MODIFICATION RECOMMENDED –
CORRECTS MANUFACTURING OR DESIGN DEFECTS

6671A-08A

S E R V I C E N O T E

6671A DC POWER SUPPLY GPIB CONTROLLED

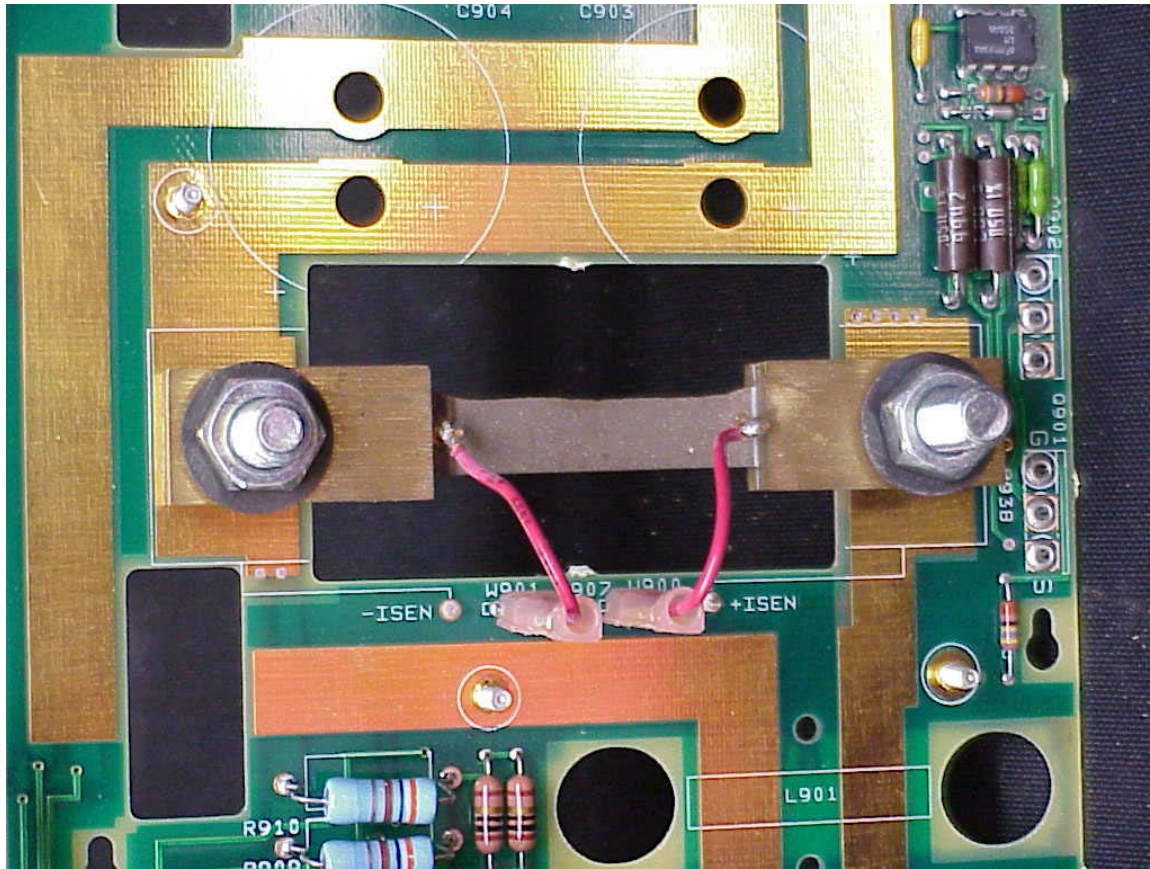
The Current Shunt (Circuit Reference “R907”) may have intermittent sense wires, which may cause instability of Current regulation, Current read back and Current programming.

When the push-on connectors become intermittent the output current will become unstable. Loose push-on connectors can cause the output current to change dramatically. The current can change from any set current, and may go to the maximum rated output current of the instrument.

This picture shows how the Shunt R907 is connected using the term-crimp connectors.

The Shunt R907 is connected to "W900" & "W901"

Cut the terminal-crimp connectors off of both wires and discard the connectors. Make this cut as close to the terminal-crimp connector as possible. The required strip length should be 5mm. This strip length will be used to prevent the wire length being too long and shorting to the instrument chassis. If replacement of this wire is required any color (22 AWG, 300V 105C) wire type can be used.

This modification can be done from the top of the board. Carefully strip and solder the wires, and avoid burning the wire insulation and the printed circuit board.

The wires should be connected as shown below. The two holes marked -ISEN & +ISEN should be used. Do not cross the wires when making this modification. See picture below for details. This picture shows the required modification.
